Dockets 50-266 and 50-301
Point Beach Nuclear Plant, Units 1 and 2
License Amendment Request 224
Control Room Habitability

DESCRIPTION AND ASSESSMENT OF CHANGES
LICENSE AMENDMENT REQUEST 224
CONTROL ROOM HABITABILITY
POINT BEACH NUCLEAR PLANT, UNITS 1 AND 2

Figure 6.2-3: CR HVAC Emergency Mode with Phase 1 Modifications Complete

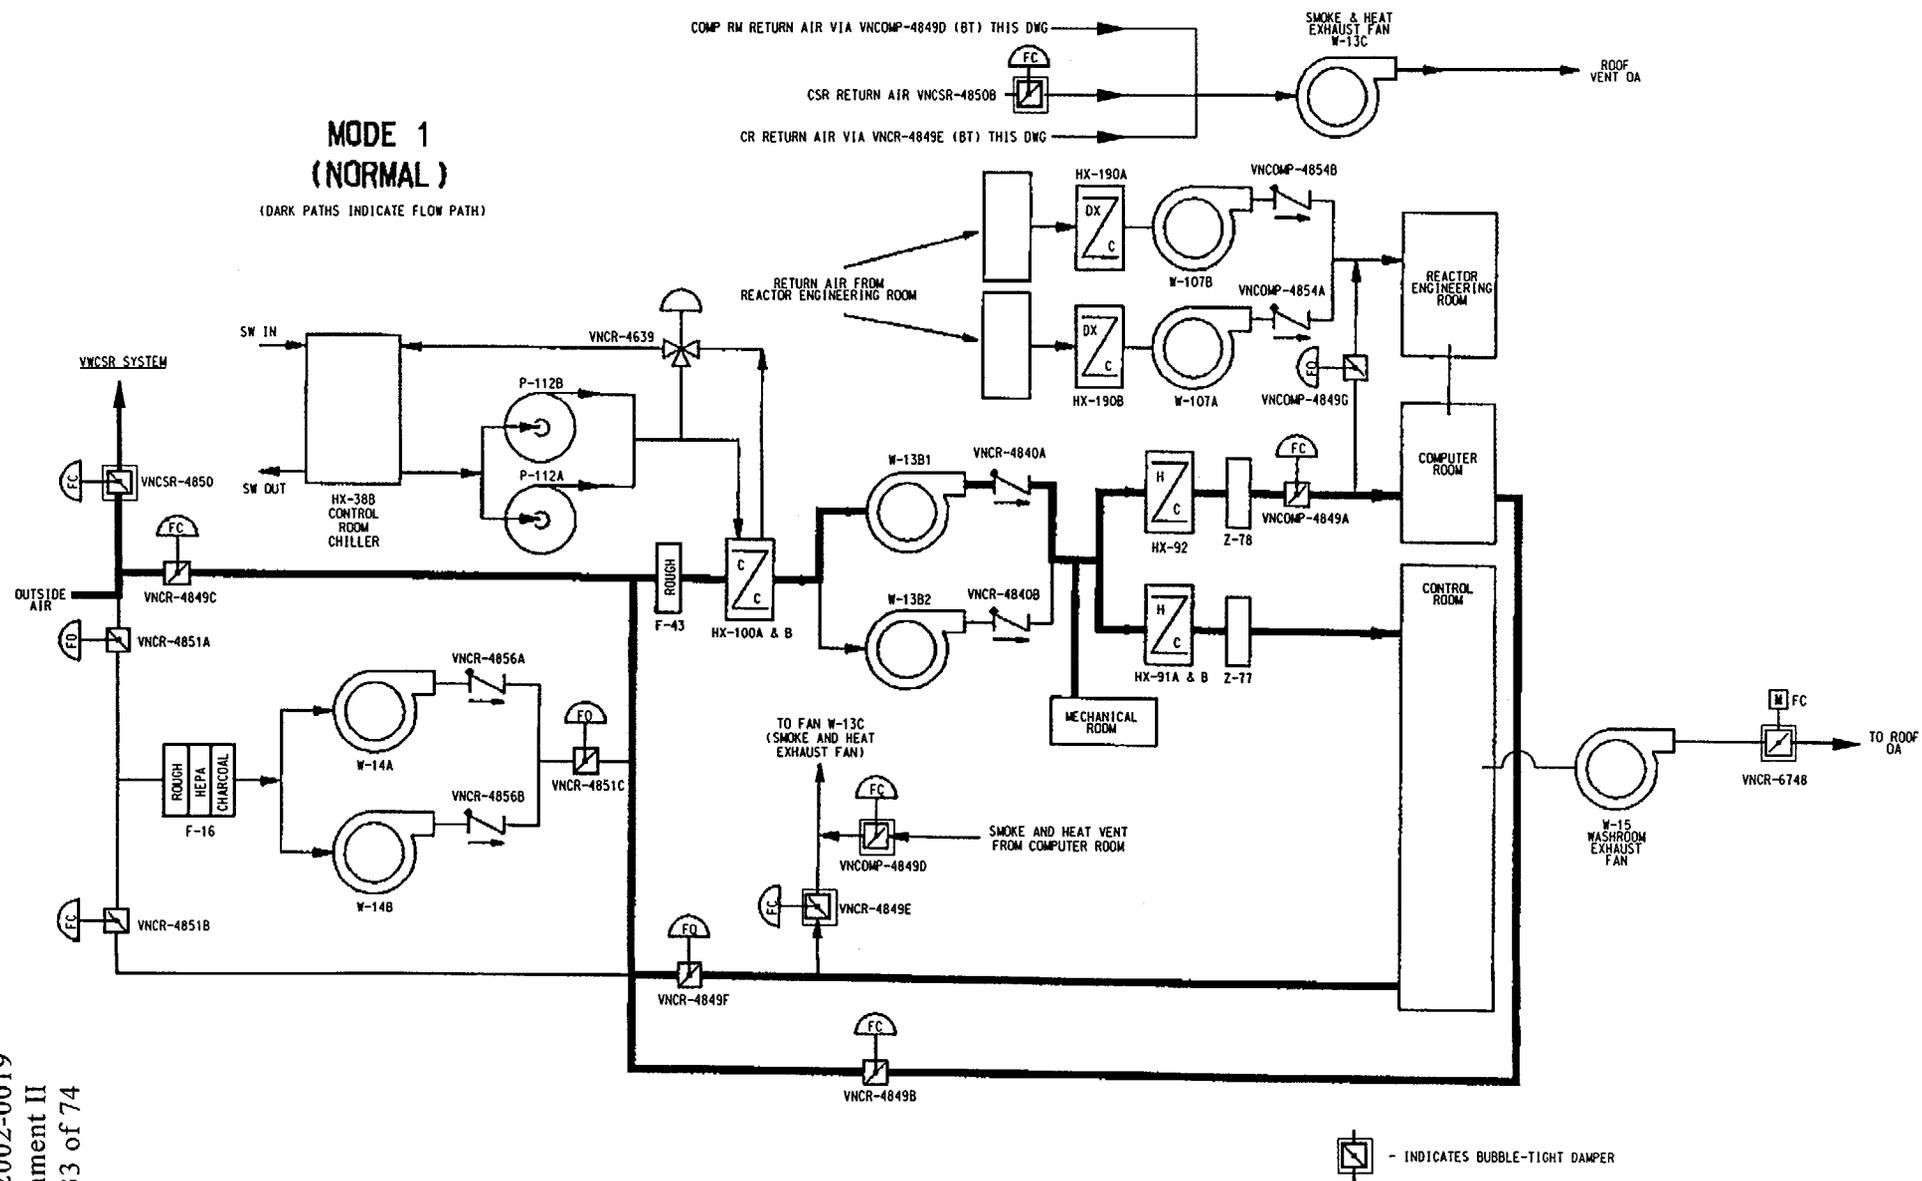
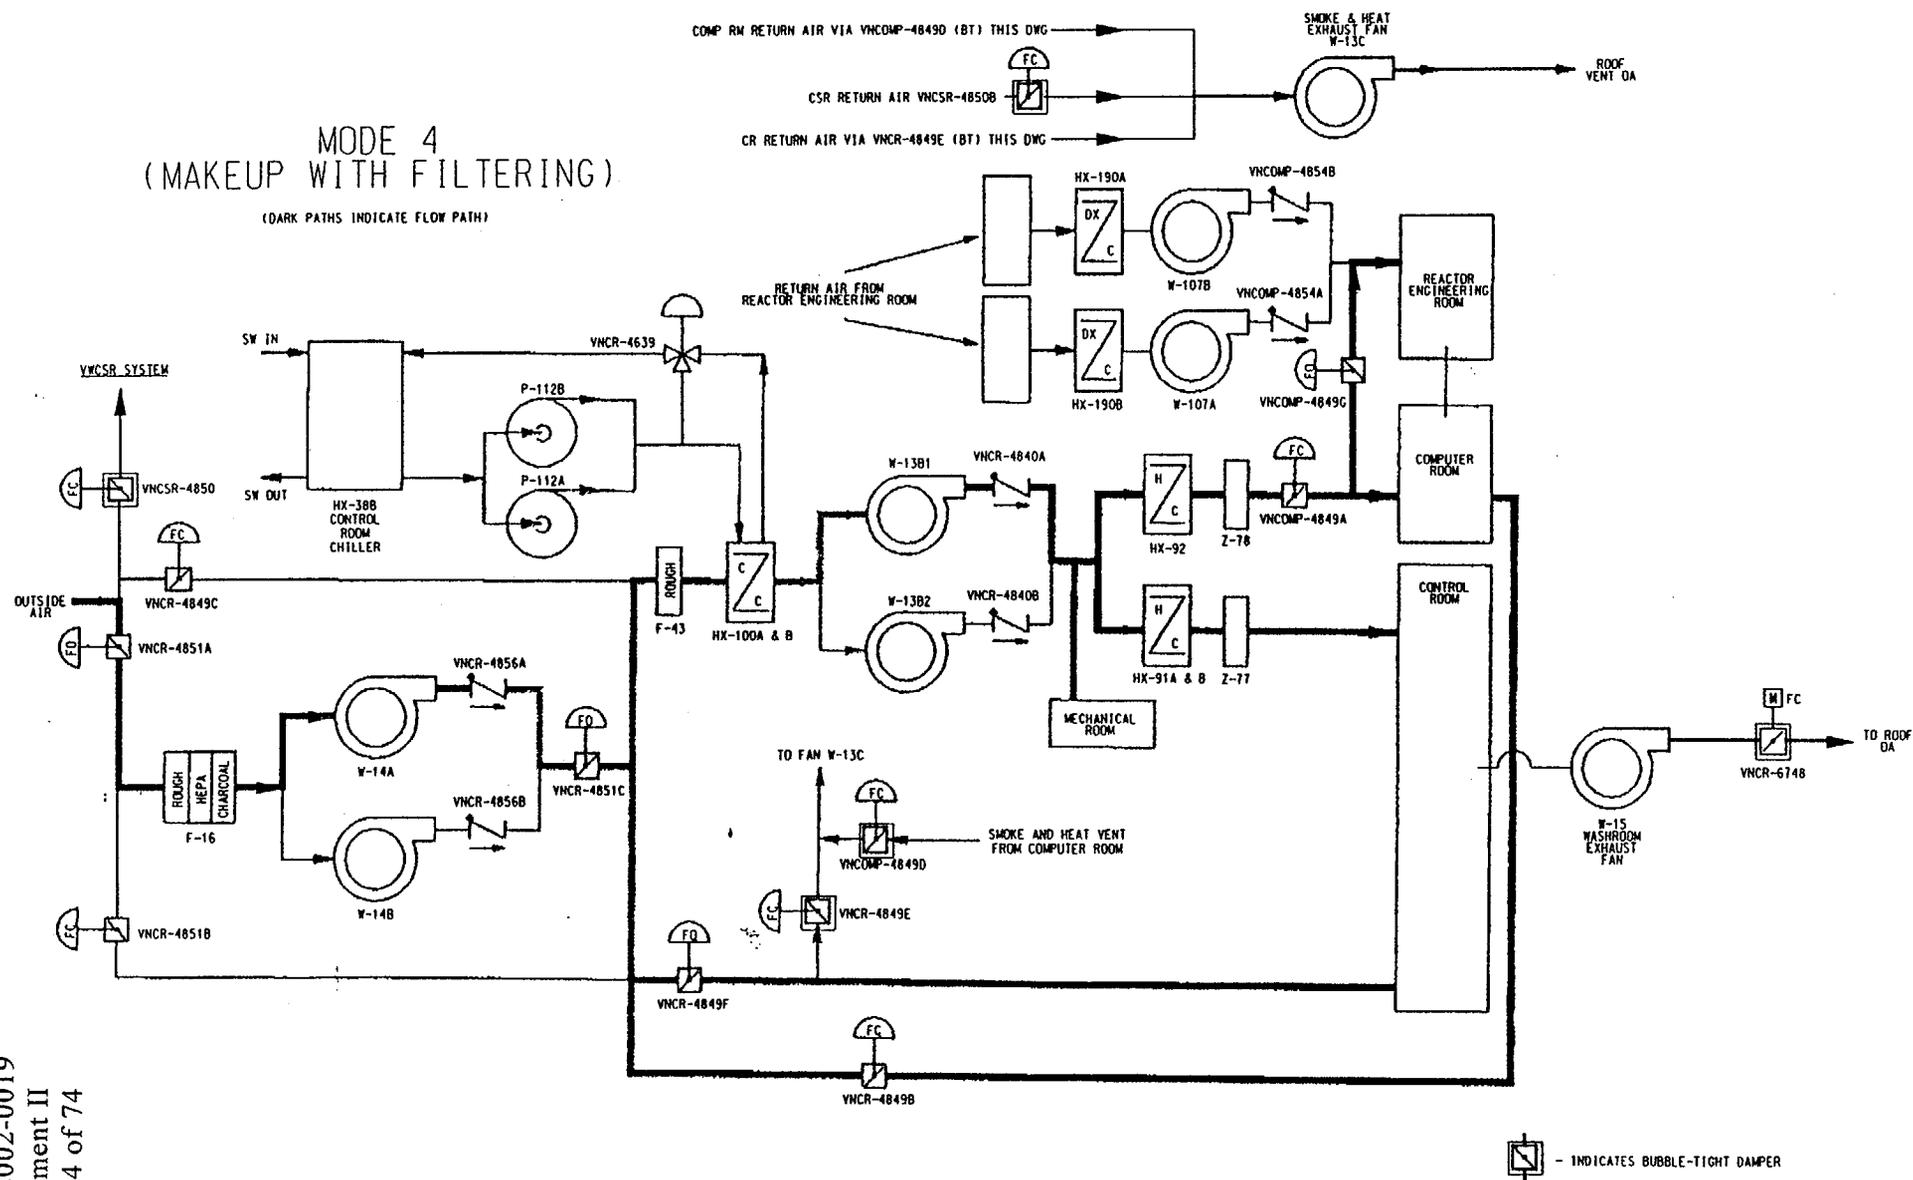
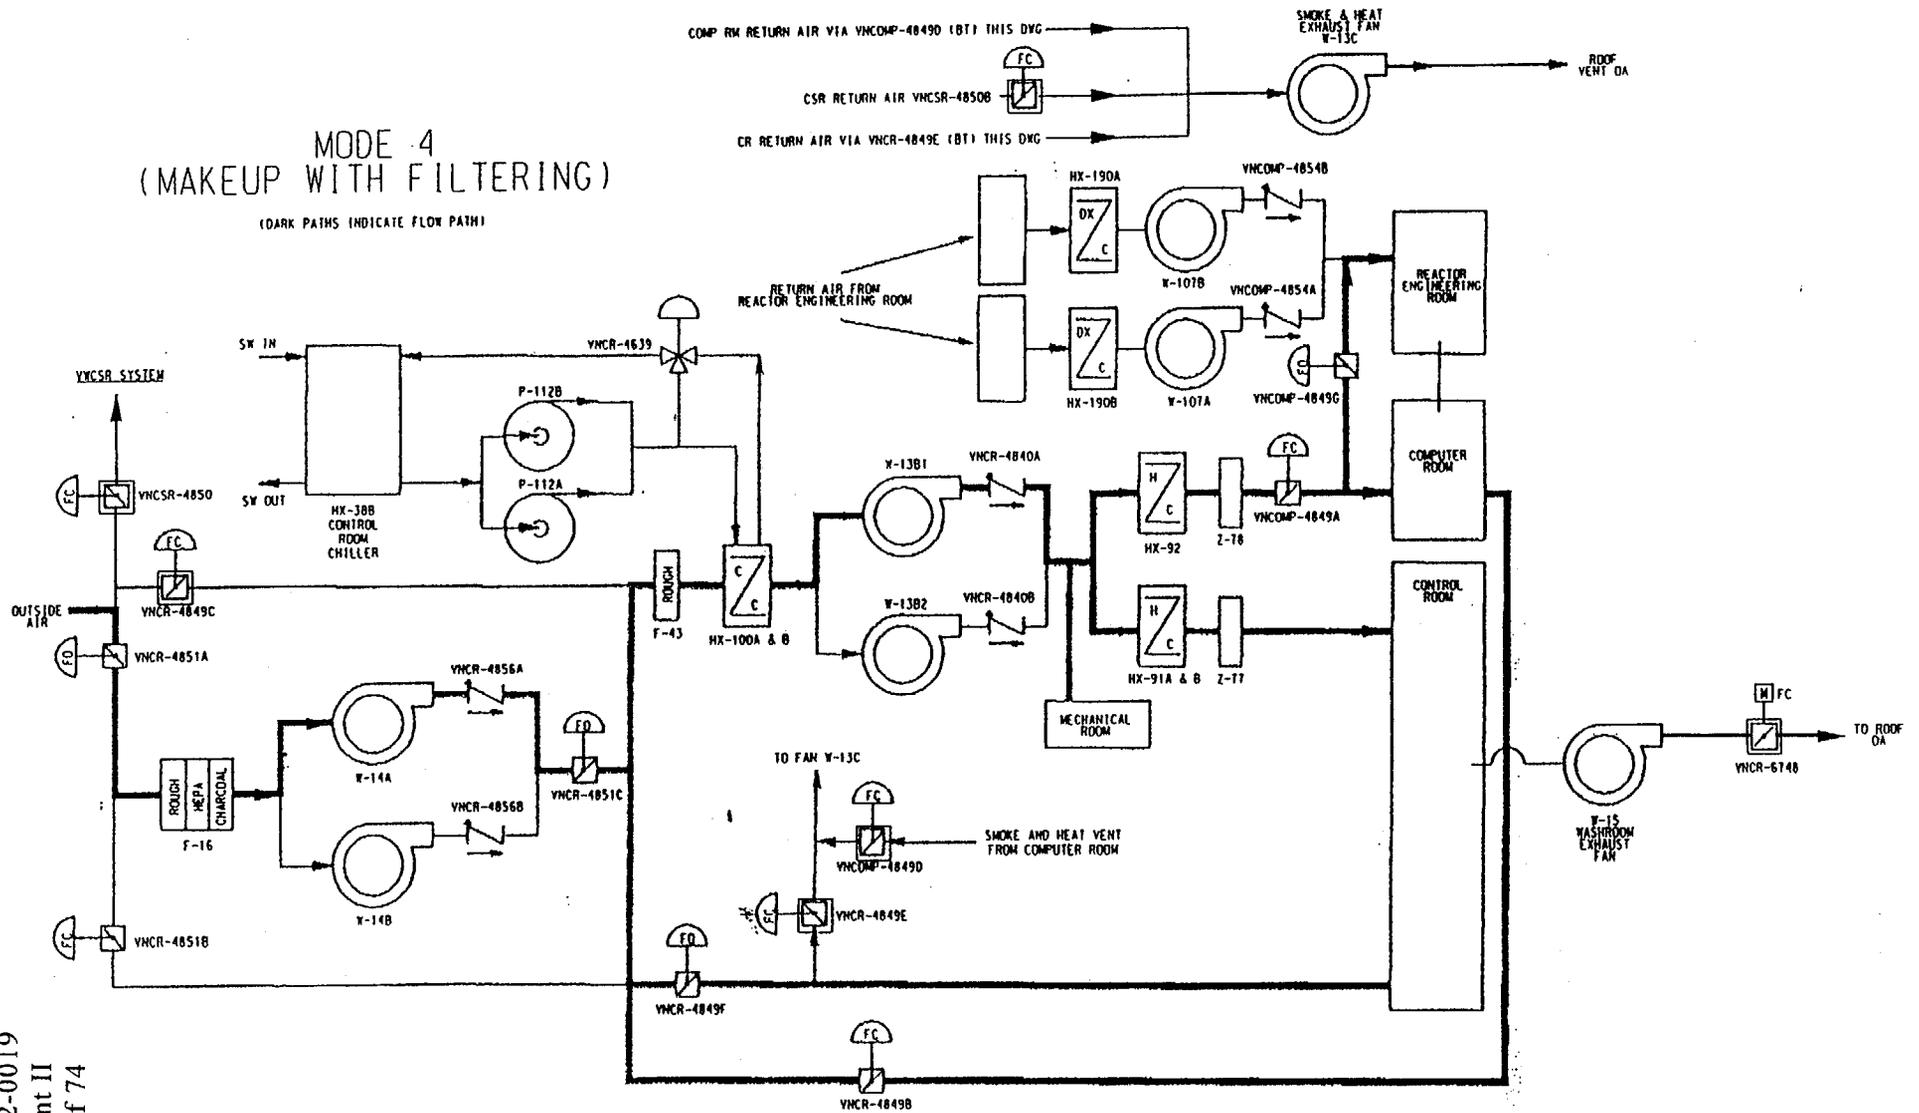
Other modifications completed to date include installation of a new balance damper and bubble tight isolation damper upstream of the cable spreading room outside air intake isolation, installation of a new bubble tight damper at the discharge of the control room washroom exhaust fan, installation of three new bubble tight dampers for the control room, computer room, and cable spreading room smoke and heat exhaust fan isolation, upgrades to the control room backup instrument air system, replacement of existing control room washroom exhaust fan with a direct drive fan and improved differential pressure indication between the control room and the turbine building (Figures 6.2-2 through 6.2-4).

The CR HVAC actuation logic will be modified such that a containment isolation signal will place the control room ventilation system directly in emergency mode of operation (Mode 4), thereby, reducing the delay time for actuation. This modification will help reduce the dose to the operator for accidents that historically had relied on the RMS high radiation setpoint to switch the operating mode of the CR HVAC.

Figure 3.4.16-1 (page 1 of 1)
Reactor Coolant DOSE EQUIVALENT I-131 Specific Activity
Limit Versus Percent of RATED THERMAL POWER

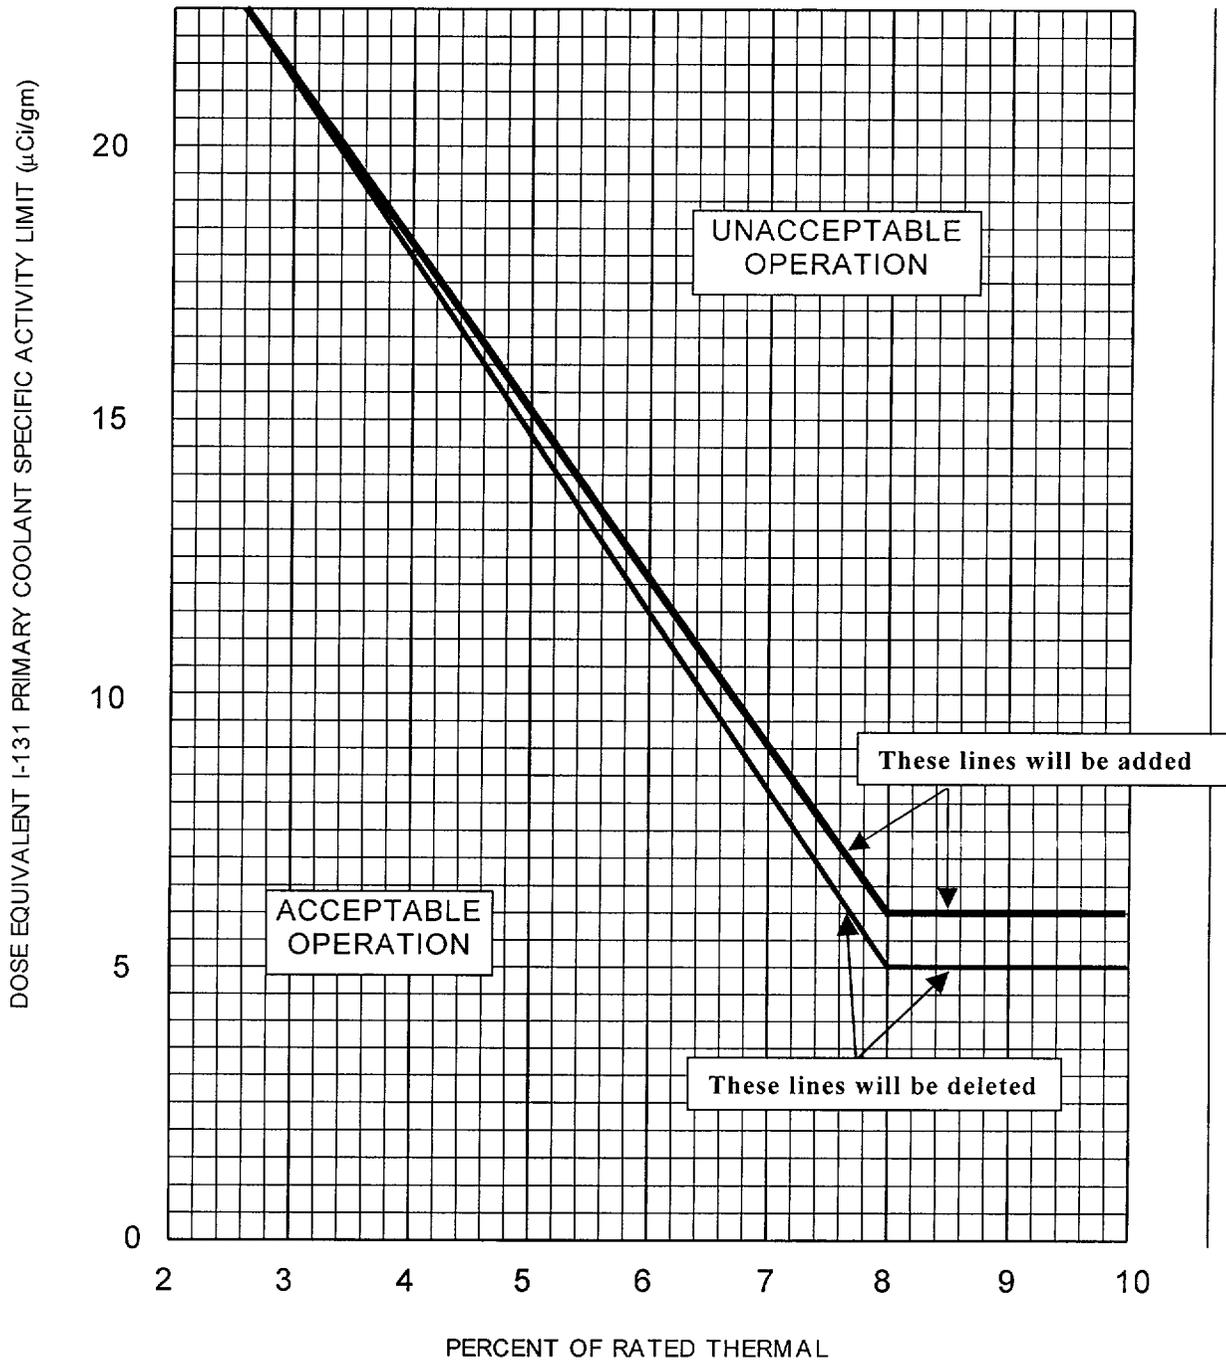
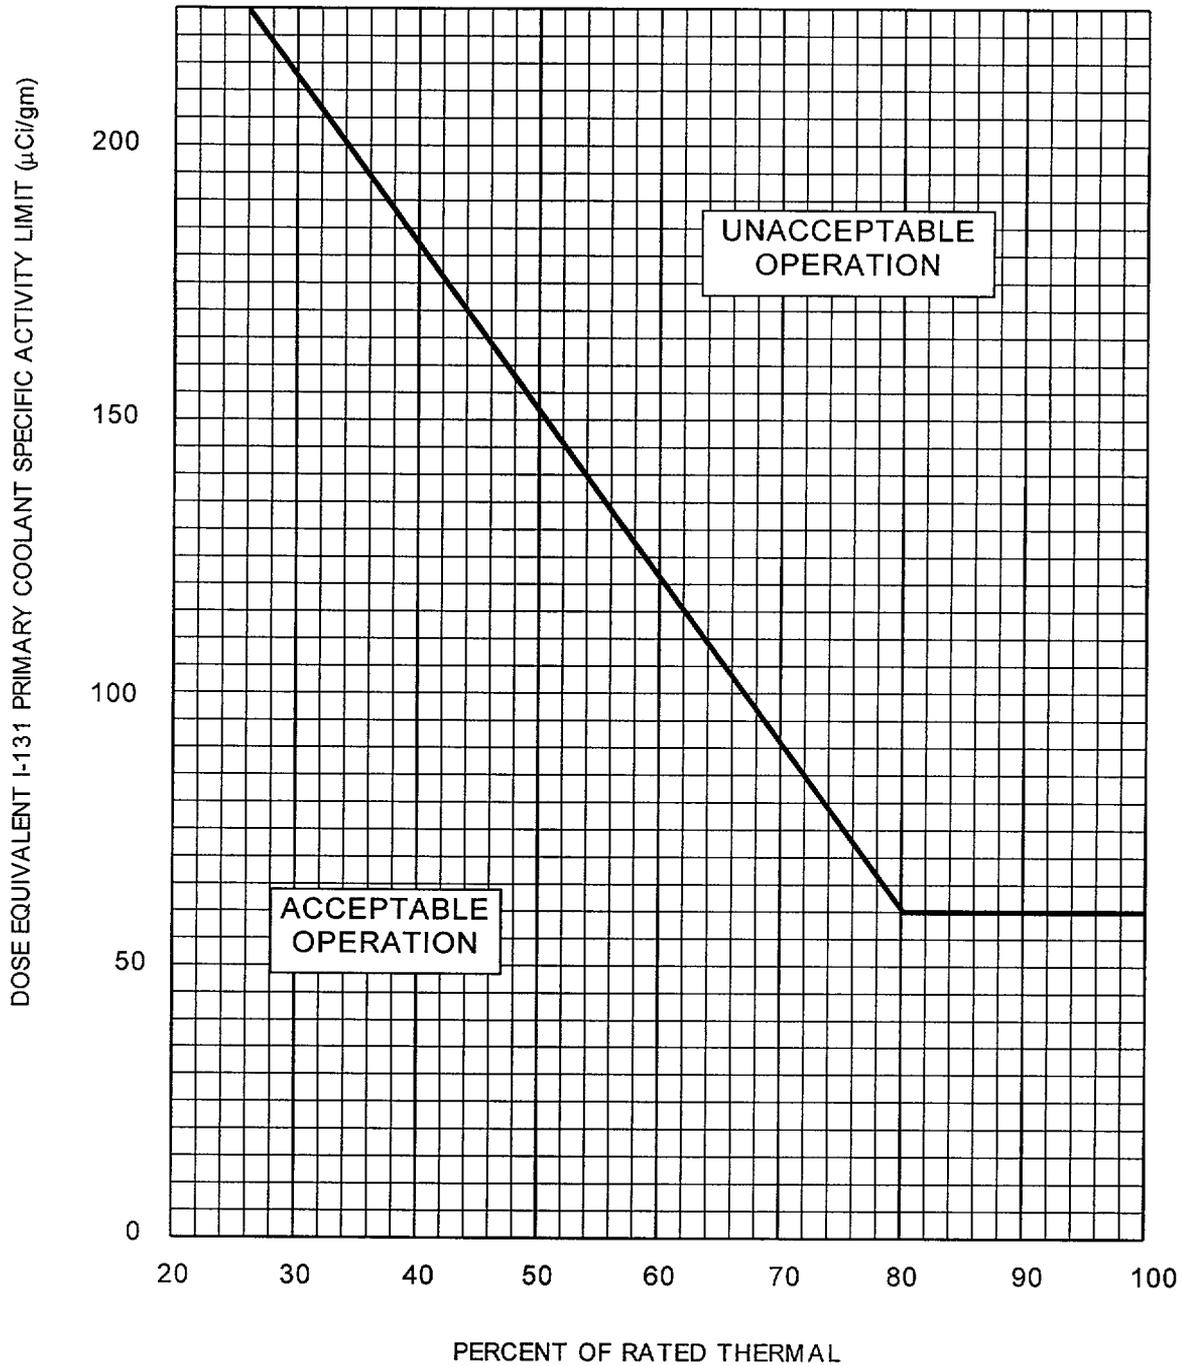
3. TS 3.4.16, "RCS Specific Activity"
 - a. Revise LCO Action Condition A to indicate 1.0 μ Ci/gm as the maximum reactor coolant dose equivalent iodine 131 (DE I-131) value.
 - b. Action Condition C references Figure 3.4.16-1, "Reactor Coolant Dose Equivalent I-131 Specific Activity Limit versus Percent of Rated Thermal Power." This figure will be revised to indicate 60 μ Ci/gm DE I-131 as the maximum RCS limit for operations at or above 80% of rated thermal power.
 - c. Revise SR 3.4.16.2 to verify 1.0 μ Ci/gm as the maximum reactor coolant DE I-131 value.
